*STP-209-1(2) Roadway and BHF-209-1(3) Bridge  
Widening of SR 74 From SR 85 to*

*P.I. Nos. 322355 and 322357*

**Value Engineering Study Report**

Preliminary Design Stage

MATCH LINE SHEET 24-09

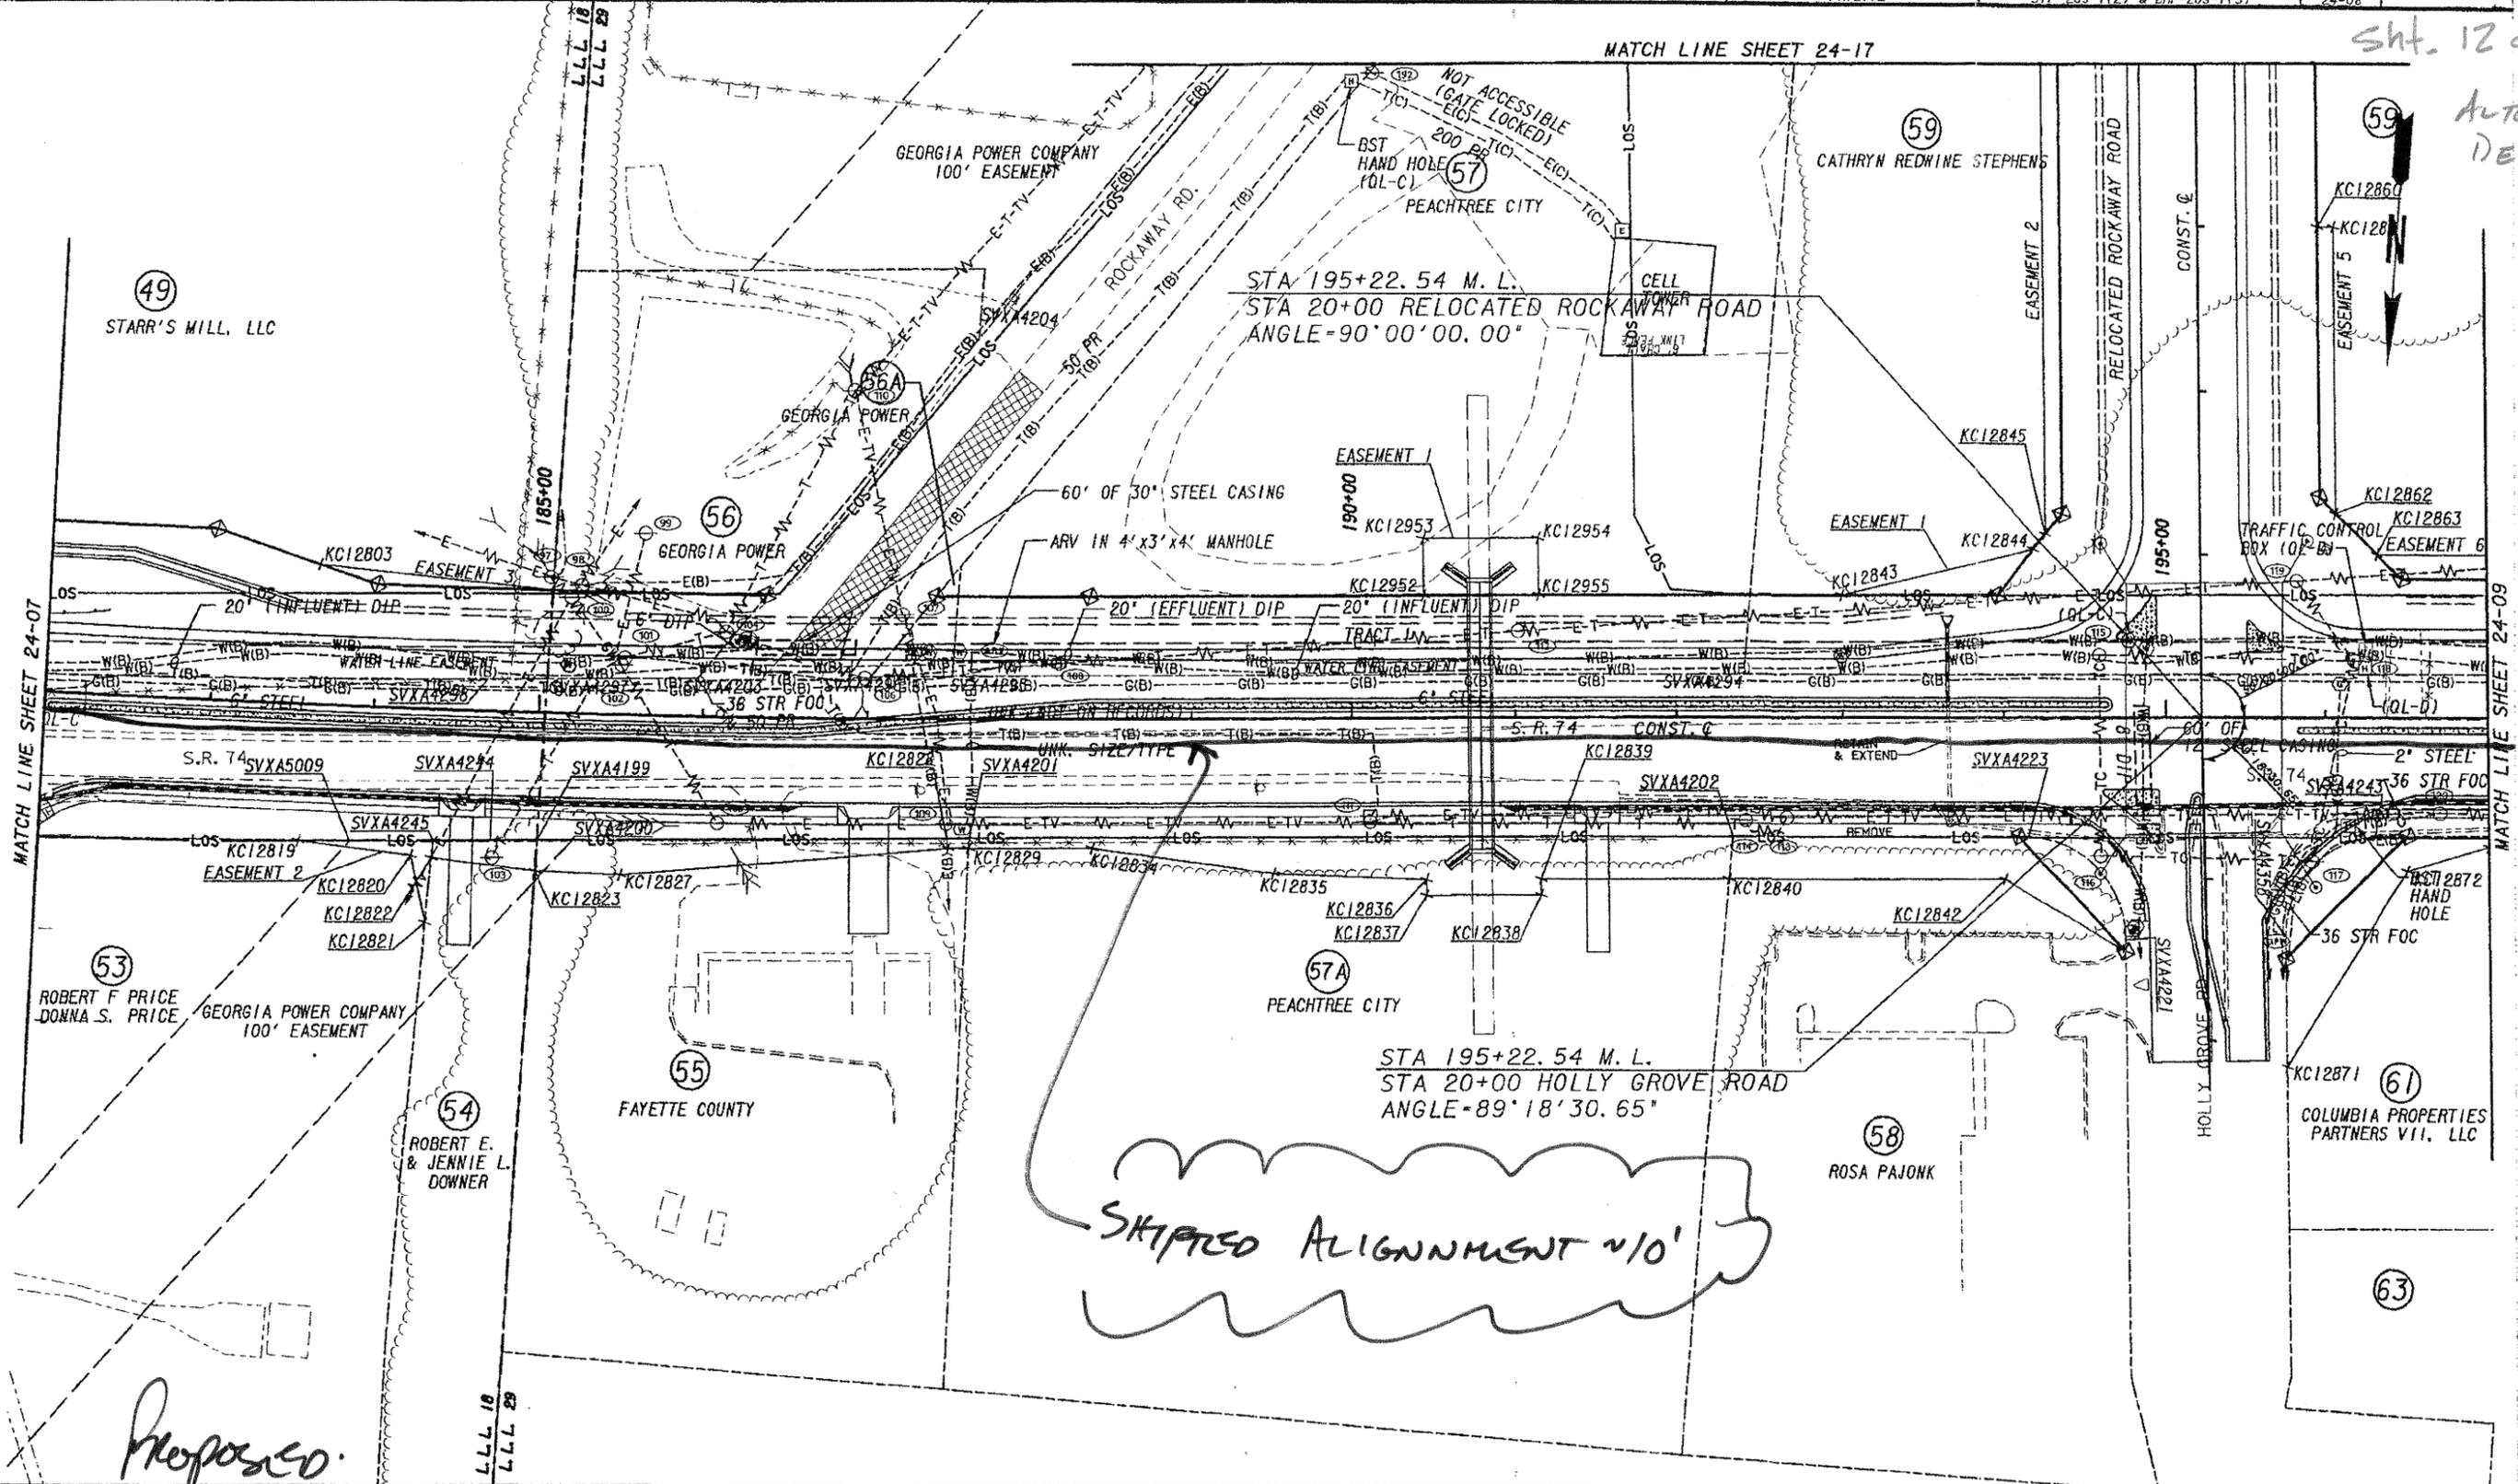
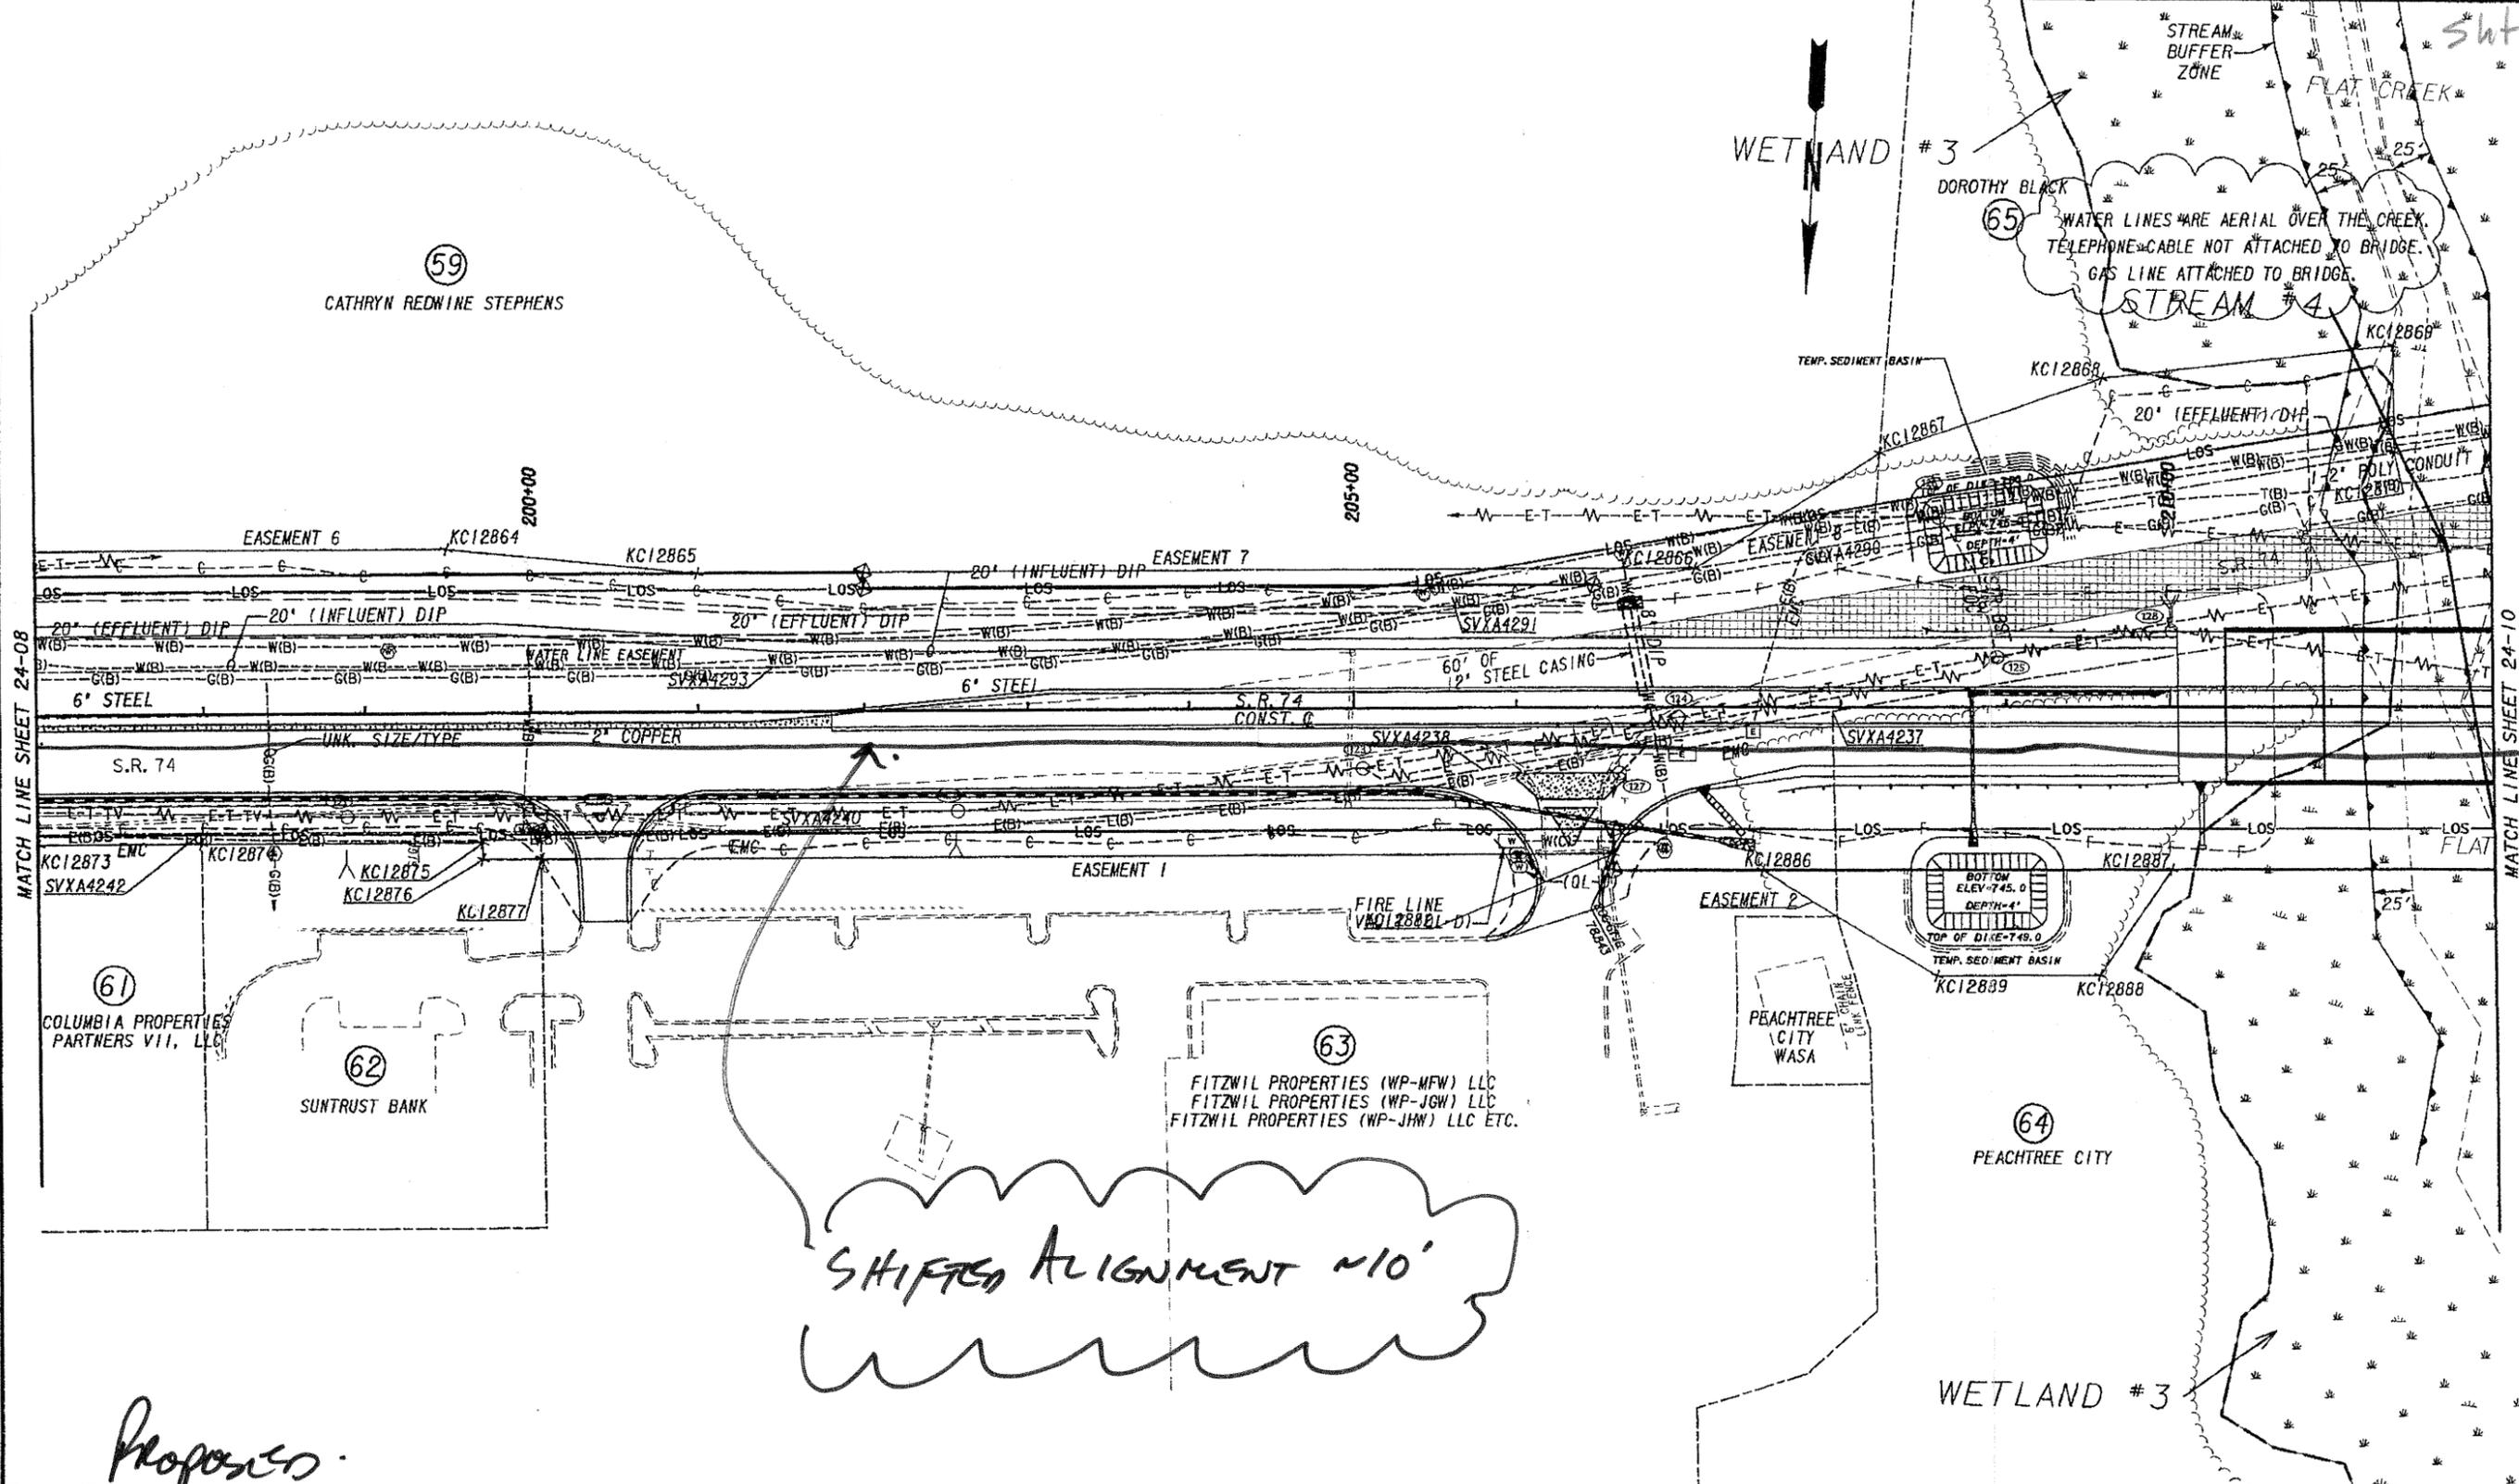
Not up to date  
Propose shifting  
new alignment to miss  
water lines.
